Work Order ID 101749

Item Name: Crosstube Low Standard Aft

DART AEROSPACE LTD		Work Order:	101749
Description: Crosstube Low Aft (412)		Part Number:	D412-664-209
Inspection Dwg: D412-664-249 Rev: B		Page 1 of 1

DRAWING NO. D412-664-249	TITLE CROSSTUBE ASS'Y (412 LOW AFT)	REV. B	DART AEROSPACE LTD ENGINEERING ORDER		D.E.O. NO. D412-664-249-B-1	SHEET NO. SHEET 1 OF 2	SCALE NTS
DRAWN <i>q</i>	CHECKED <i>SC</i>	MFG. APPR. <i>E</i>		APPROVED <i>MD</i>	DE APPR. <i>MD</i>		
DATE 11.05.25	DATE 11.05.31	DATE 11.05.31		DATE 11/05/31	DATE 11.05.31

**D412-664-249
ASSEMBLY DETAIL**

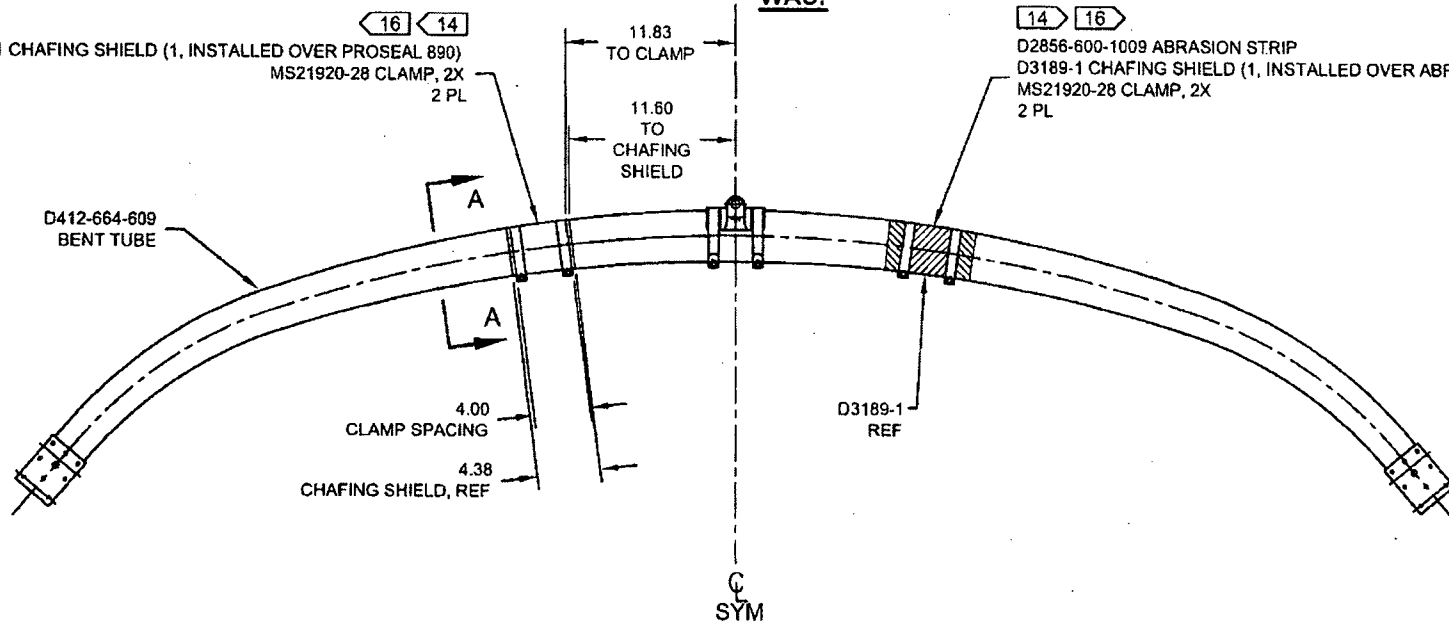
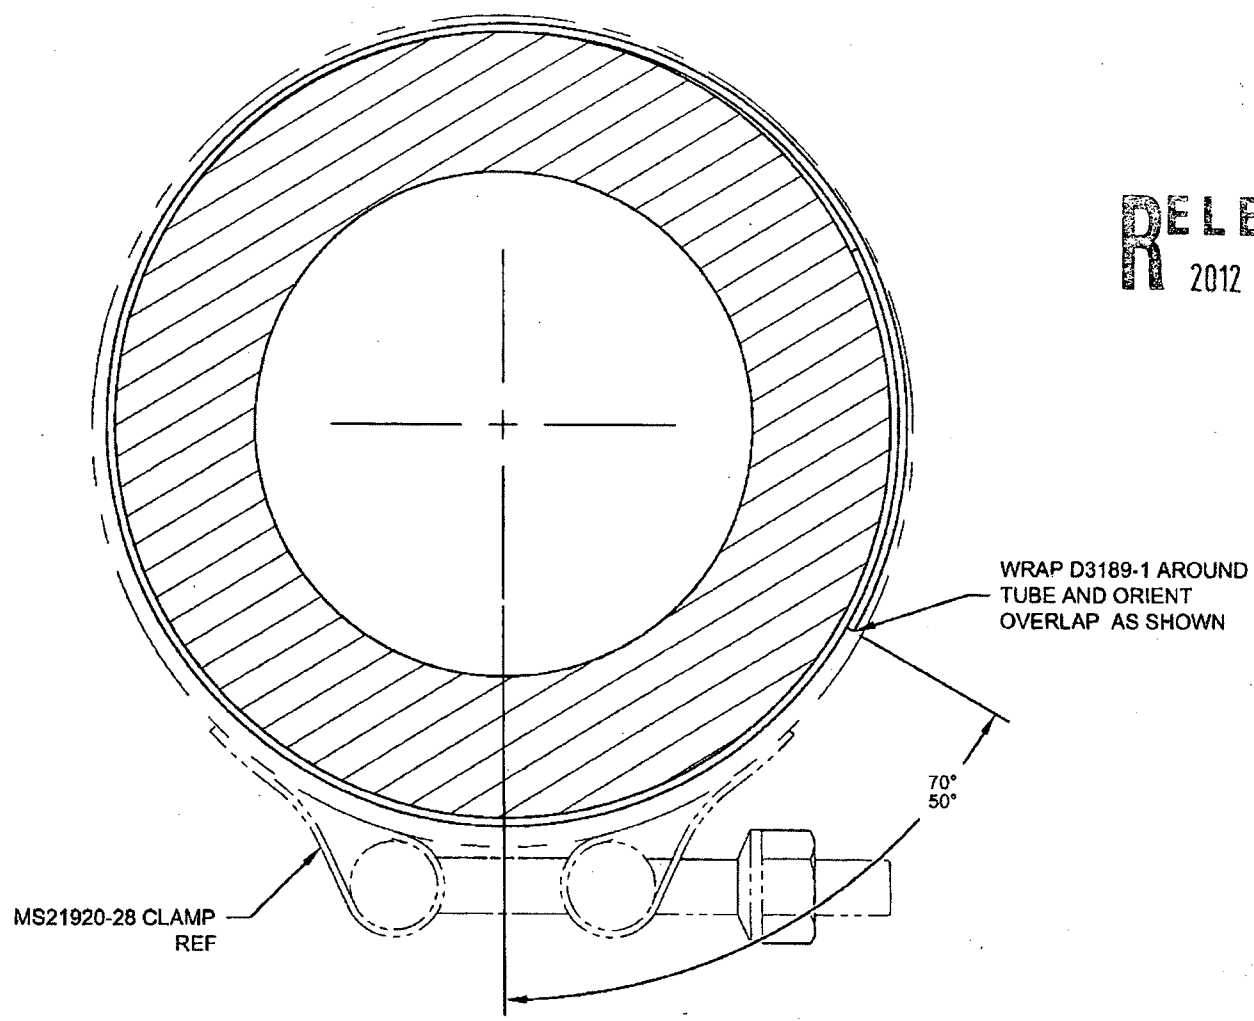
IS:

D3189-1 CHAFING SHIELD (1, INSTALLED OVER PROSEAL 890)
MS21920-28 CLAMP, 2X
2 PL

WAS:

SECTION A-A
CHAFING SHIELD DETAIL
VIEW ROTATED, NOT TO SCALE
